# Access Compliance Report Public Rights-of-Way (Curb Ramps)

| Main Street: WEATHERBY_RD               |                              | Cross Street: CORTESE_DR |                                         | Location:       | SW |
| ADA ID: RPRK211217133108                | Ramp Type: Type 4 - Parallel | Initial Pass/Fail: Fail  | Overall Compliance: No                  | Severity Score: | 2  |

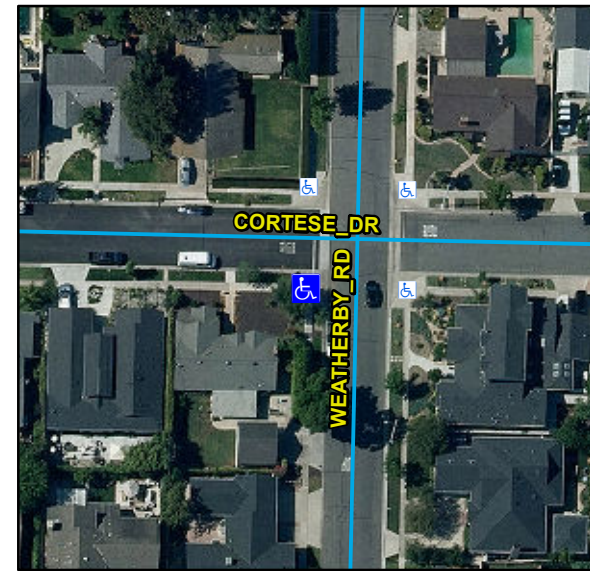
| Compliance | Description                   | Data       | Compliance | Description                   | Data |
|------------|-------------------------------|------------|------------|-------------------------------|------|
| No         | Ramp Cross Slope LT (%)       | 3.2        | Yes        | Ramp Cross Slope RT (%)       | 2    |

**Remove & Replace Curb Ramp With Two New Directional Ramps or Equivalent.**

**R304.5.3, STD 1115**
